PAGES TO BE AMENDED

viii	3/4.5-17
1.0-2	3/4.5-18
1.0-5	3/4.5-19 (deletion)
1.0-6	3/4.5-20 (deletion)
1/2.1-1	3/4.5-21 (deletion)
1/2.1-2	3/4.5-22
1/2.1-3	3/4.5-23 (replaced with two figures)
1/2.1-4	3/4.5-24
B1/2.1-7	3/4.5-25
B1/2.1-8	3/4.5-26
B1/2.1-12	3/4.5-27
B1/2.1-14	3/4.5-28 (replaced with single figure)
3/4.1-1	3/4.5-29
3/4.1-2	B3/4.5-34
B3/4.1-20	B3/4.5-37
3/4.2-12	B3/4.5-38
3/4.2-13	B3/4.5-39
3/4.3-11	B3/4.5-42
3/4.3-19	3/4.6-15
B3/4.3-20	3/4.6-16
3/4.5-8	B3/4.6-36
3/4.5-9	B3/4.6-37
3/4.5-15	3/4.10-8
3/4.5-16

The Technical Specifications contained in Appendix A, as revised through Amendment ^{TBD} 98 are hereby incorporated in the license. The licensee shall operate the facility in accordance with the Technical Specifications.

Figure 3.5-2 (Sheet 1 of 2)

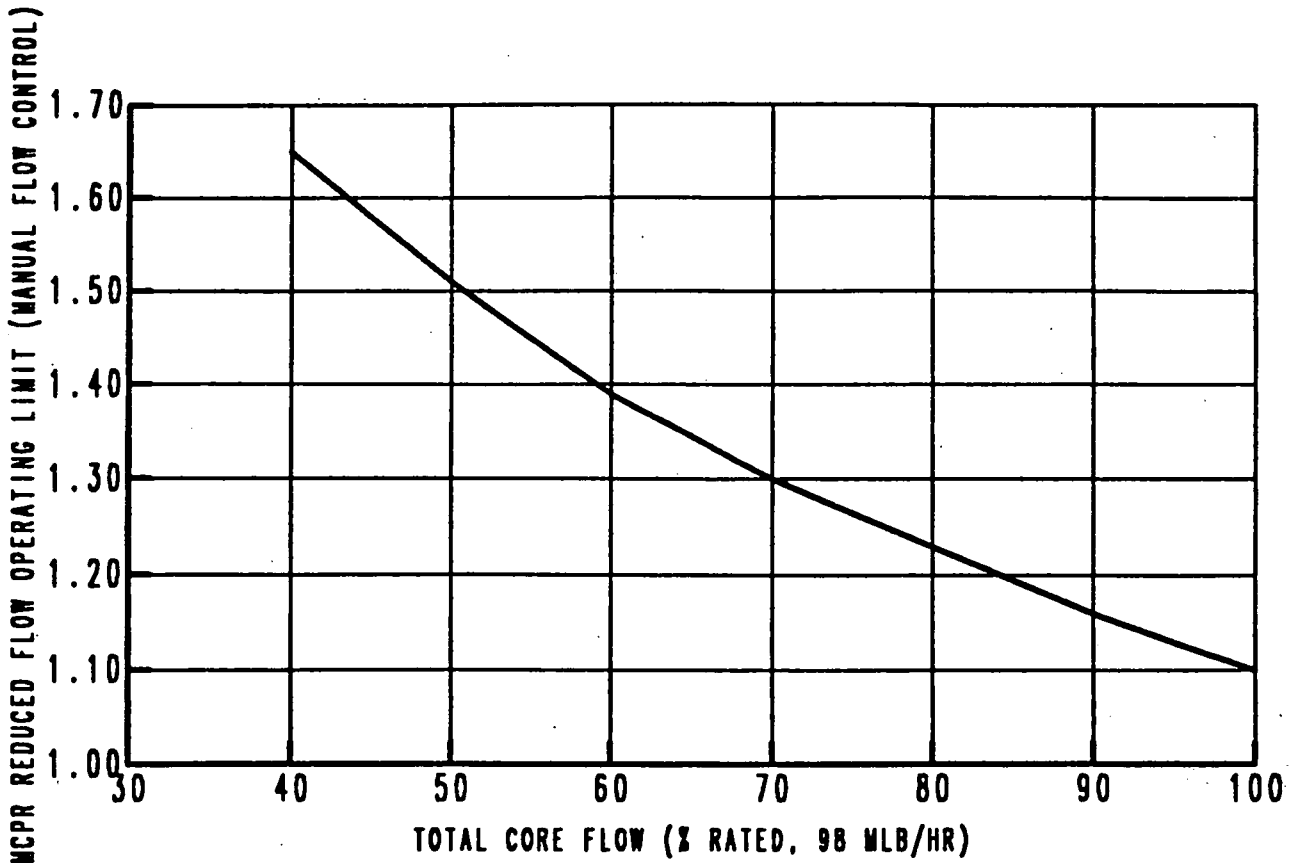
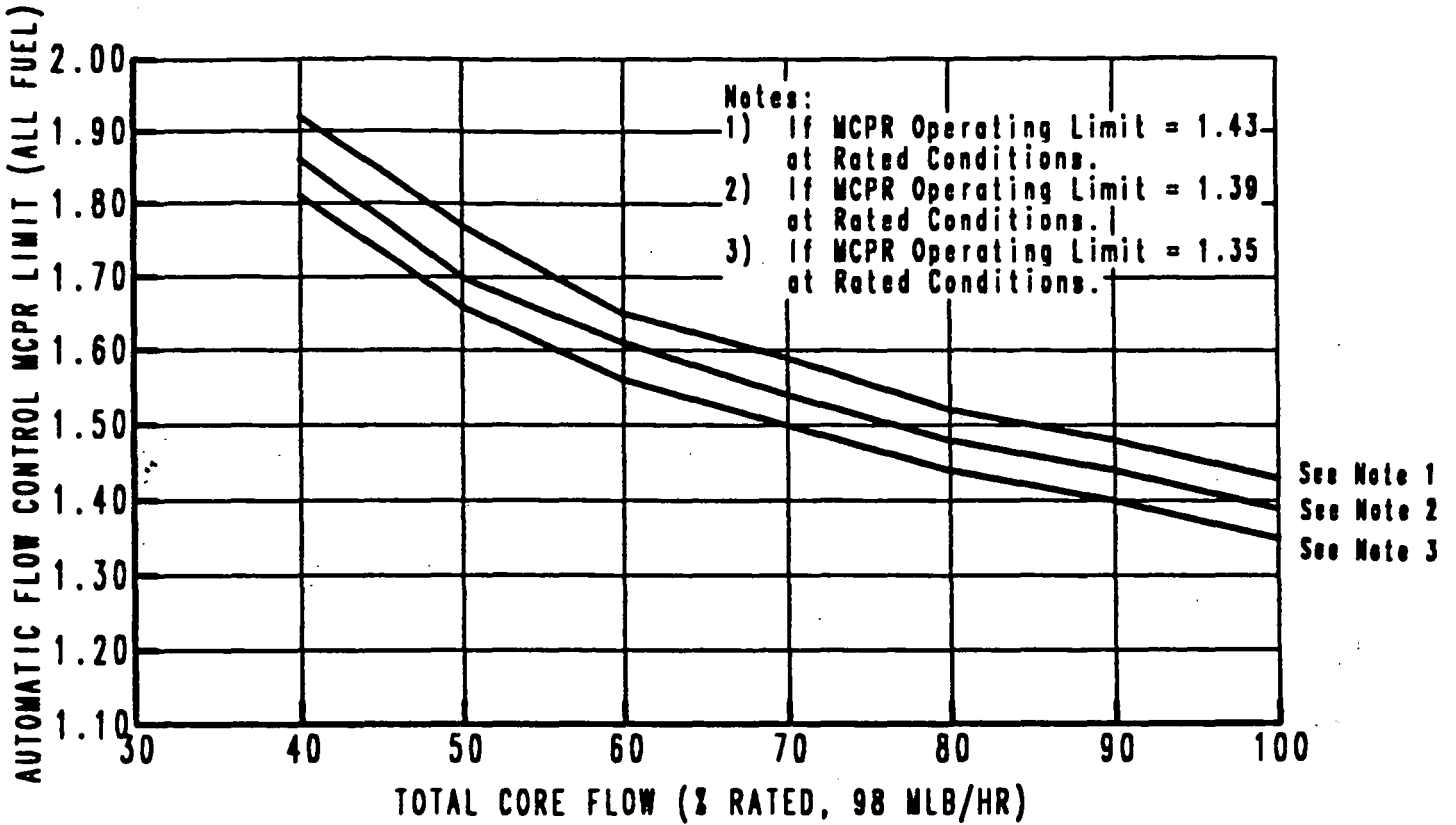
replace with insert of 3/4.5-29

Total Core Flow (% Rated)	MCPR Operating Limit
100	1.10
90	1.16
80	1.23
70	1.30
60	1.39
50	1.51
40	1.65

M CPR Operating Limit for Automatic Flow Control

The above curve is based on the following M CPR operating limit summary for Automatic Flow Control and all fuel types:
